**Spare Parts Requirements - When Working on the Maintenance Flaps in the Rear Doors: Replacing Covers on Maintenance Flaps (136/18)**

Vehicle Type: **Macan (95B)**

Model Year: **As of 2018 up to 2019**

Subject: **Covers on maintenance flaps in the rear doors**

*Tape on maintenance flap cover*

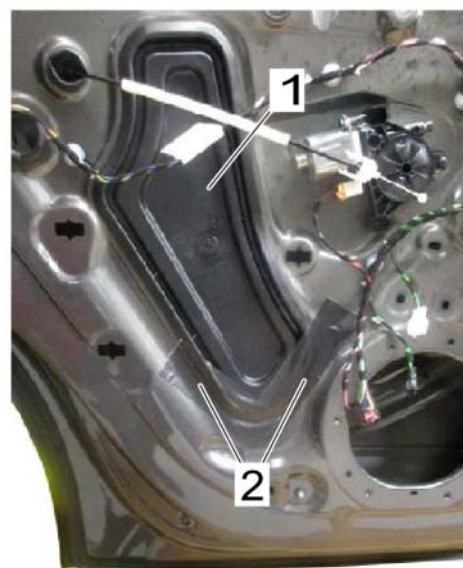
Information: **Moisture can seep into the dry area of the vehicle.**

- Vehicles produced during the usage period may have been fitted with covers (⇒ *Tape on maintenance flap cover -1-*) with excessive tolerances.
- The affected covers can be identified by the tape (⇒ *Tape on maintenance flap cover -2-*).

- The part number of the **left/right cover** has **not** changed, only the tolerance range was optimised. The new left/right cover must be **re-ordered** accordingly.

When working on the maintenance flaps in the rear doors

- on a vehicle that was produced during the usage period
- and if there is tape

⇒ replace the existing covers with re-ordered covers.
